STAFF RECOMMENDATION
1100 Gilmore Avenue
September 20, 2017

Application: New construction—addition
District: Waverly-Belmont Neighborhood Conservation Zoning Overlay
Council District: 07
Map and Parcel Number: 11801010600
Applicant: Kaitlyn Smous, Nine12 Design
Project Lead: Melissa Baldock, melissa.baldock@nashville.gov

<p>Description of Project: Application is to construct an addition to the side of the house.</p> <p>Recommendation Summary: Staff recommends disapproval, finding that the addition’s design, location, height, scale, setback and rhythm of spacing, materials, roof shape, orientation, and proportion and rhythm of openings do not meet Sections III.A., III.B., III.C., III.D., III.E, III.F., III.G., and IV. of the Waverly-Belmont Neighborhood Conservation Zoning Overlay.</p>	<p>Attachments A: Site Plan B: Elevations</p>
--	--

Proposed location of the new addition.

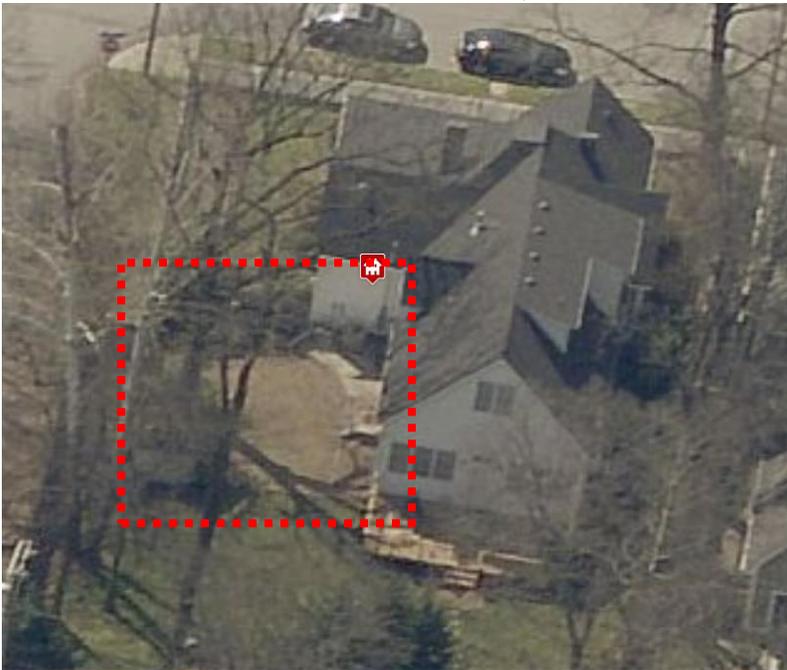
Location: A side addition could be appropriate at 1100 Gilmore Avenue because the lot is unusually wide at seventy-five feet (75'). However staff finds that the addition's location is inappropriate in this instance because its design reads more as an outbuilding than a side porch addition. Outbuildings should be located in the established rear yards, not in the side yards. An addition with this proposed design is not appropriate in a side yard. Staff therefore finds that the addition's location does not meet Section IV.A. of the design guidelines.

A1.1

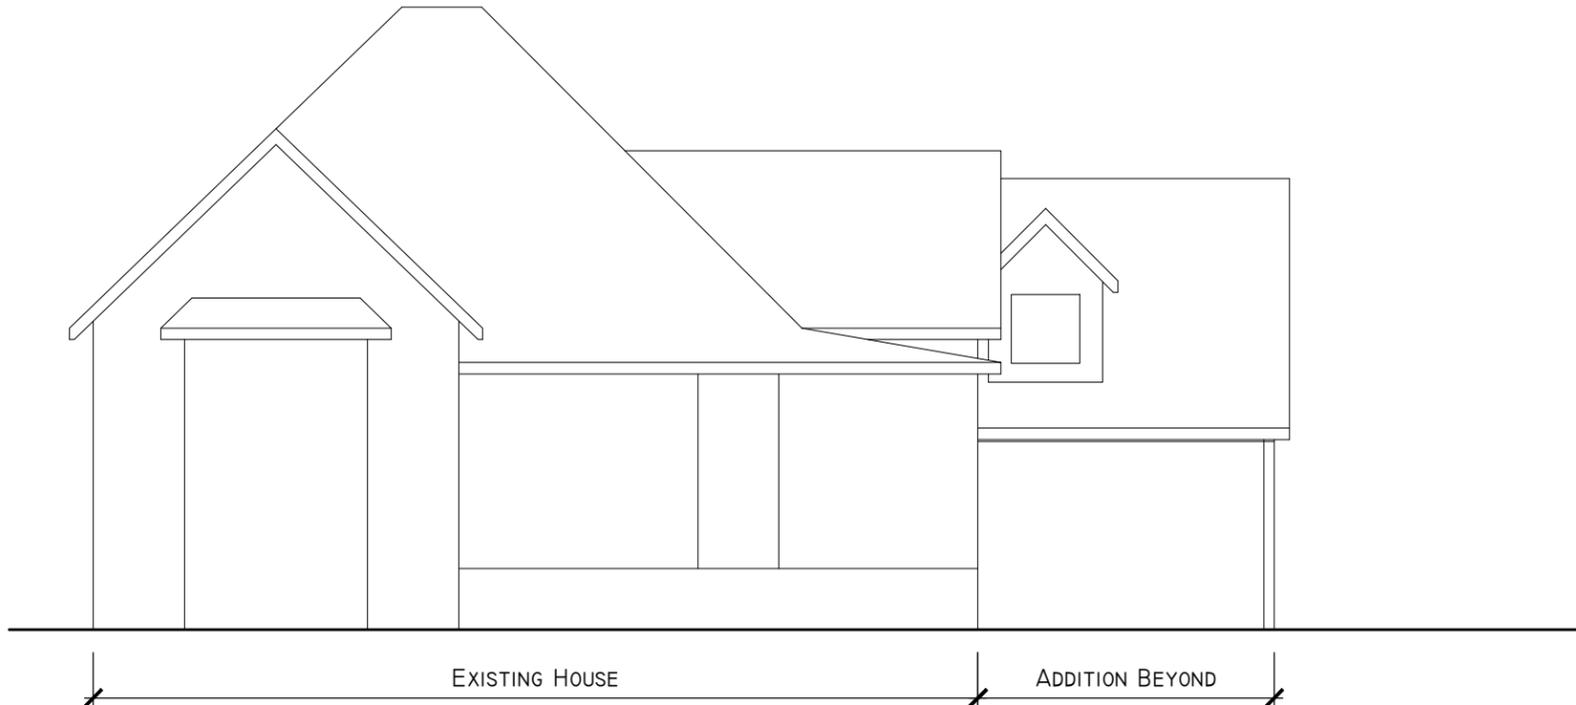
The addition is attached to the historic house with a connector that is five feet, four inches (5’4”) wide and ten feet, six inches (10’6”) deep. The bulk of the addition will be twenty feet (20’) wide and thirty-one feet (31’) deep. Although the overall scale of the addition is subordinate to the historic structure, staff finds that its minimal connection to the historic house has a scale that is not in keeping with typical side porches. Staff finds that the connector does not meet the design guidelines for scale. Staff therefore finds that the addition’s height and scale do not meet Sections III.A., III.B., and IV. B. of the design guidelines.

Setback & Rhythm of Spacing: The addition meets all base zoning setbacks. It will be thirteen feet, four inches (13’4”) from the 11th Avenue South side property line, and forty-six feet, six inches (46’6”) from the rear property line.

A2.0

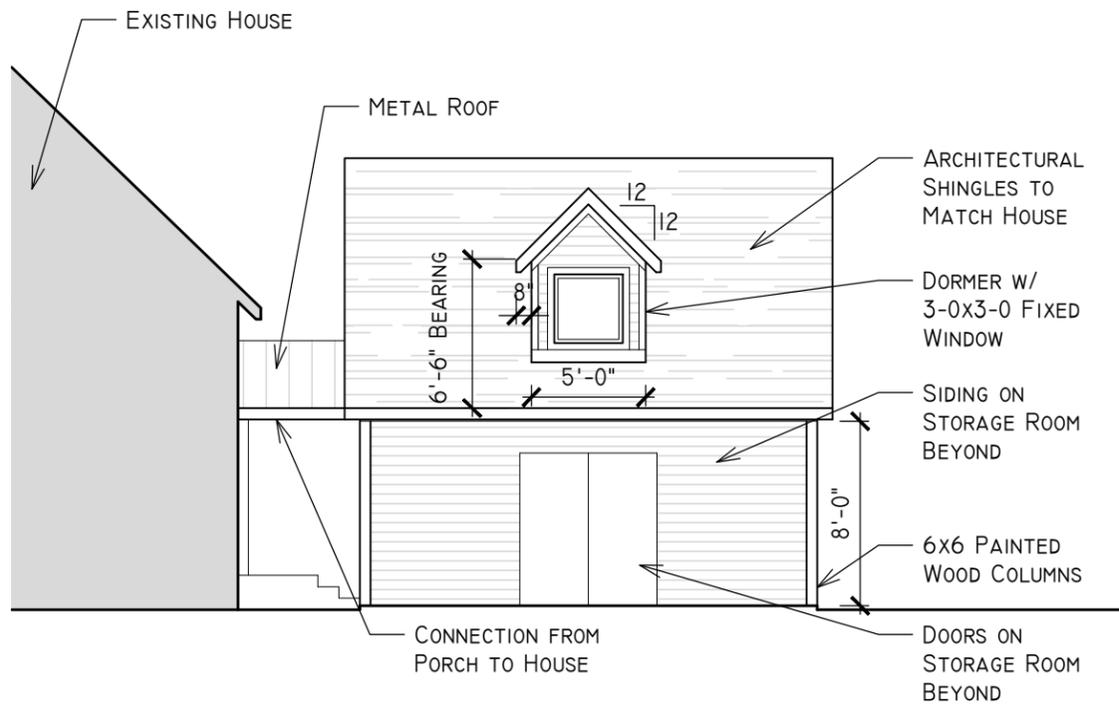
The applicant refers to the addition as a porch. However, the large opening facing Gilmore Avenue is more typical of a carport or a porte cochere than it is a porch. In addition, the plans show a driveway leading into the covered space. The opening is approximately nineteen feet (19') wide and eight feet, six inches (8'6") tall and covers the entire span of the front façade of the porch. It is a large void that is atypical for additions, even if they are porches. In staff's review of historic side porches, the widest porch was twelve feet (12'). Typical side porches, whether or not they are screened, have more columns within a span of the nineteen feet (19').

Proportion and Rhythm of Openings: No changes to the window and door openings on the existing house were indicated on the plans. As mentioned under "Design," the large, nineteen foot (19') wide by eight foot, six inches (8'6") tall opening facing Gilmore

Avenue is more typical of a carport than it is an addition or porch. Staff finds that this size opening is not found on historic side porches and is not appropriate for a side addition. Staff therefore finds that the proposed addition does not meet Section III.G. of the design guidelines.
